SUBJECT: NuScale Power, LLC Response to NRC Request for Additional Information No. 202 (eRAI No. 8911) on the NuScale Design Certification Application

Response to Request for Additional Information Docket No. 52-048

eRAI No.: 8911

NRC Question No.: 03.09.02-43

Figure B-21 Design ISRS, top of lower core plate, location 16, Y-direction (vertical)

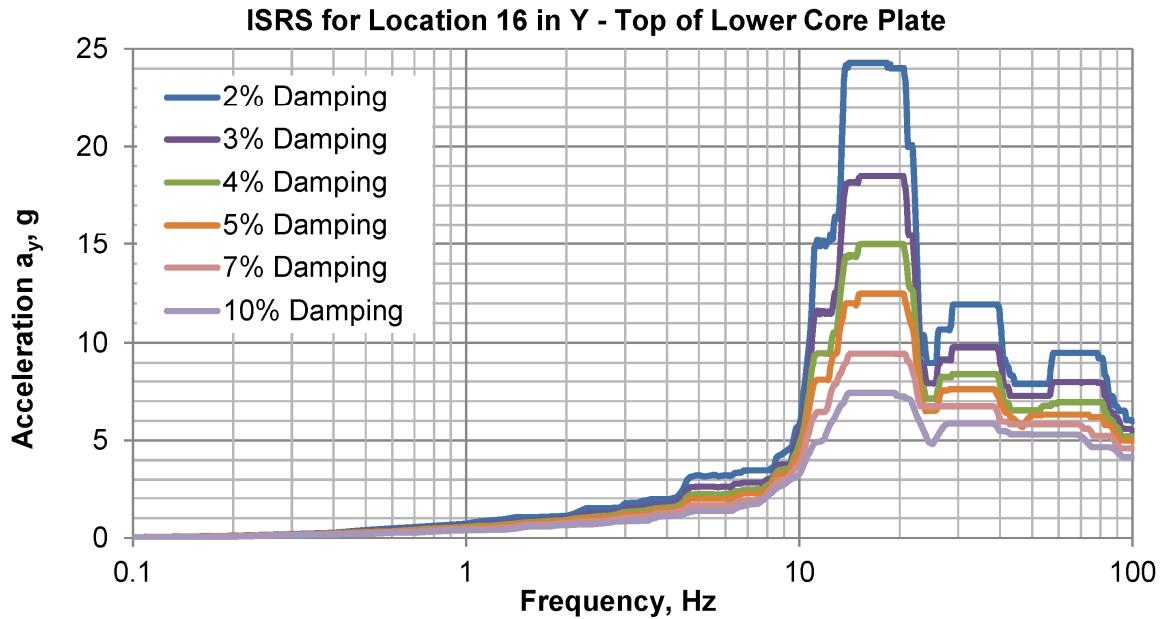
1. Figure B-18 (vertical ISRS at top of the lower core plate) indicates that the maximum vertical acceleration at top of the lower core plate is about 1.6 g (i.e., spectral acceleration at the high frequency end of the ISRS) that exceeds gravity acceleration. Provide a discussion on the possibility of uplift between the reflector blocks as well as between the reflector blocks and the lower core plate under the maximum vertical acceleration and their consequence.
2. Provide the vertical ISRS and the maximum vertical acceleration at the interface between the upper riser and the lower riser. Provide a discussion on the possibility of uplift of the upper riser from the lower riser under the maximum vertical acceleration and their

The maximum uplift between the first reflector block and the lower core plate is calculated to be {{ }}^{2(a),(c)} (TR Table 8-9). This amount of uplift produces an increased vertical response spectrum for the lower core plate in the range from {{ }}^{2(a),(c)} (TR Figure B-21) and an associated vertical impact force on the lower core plate of {{ }}^{2(a),(c)} (TR Table 8-8). However, only a fraction of this vertical impact force {{ }}^{2(a),(c)} is transmitted to the fuel (TR Table 8-8).
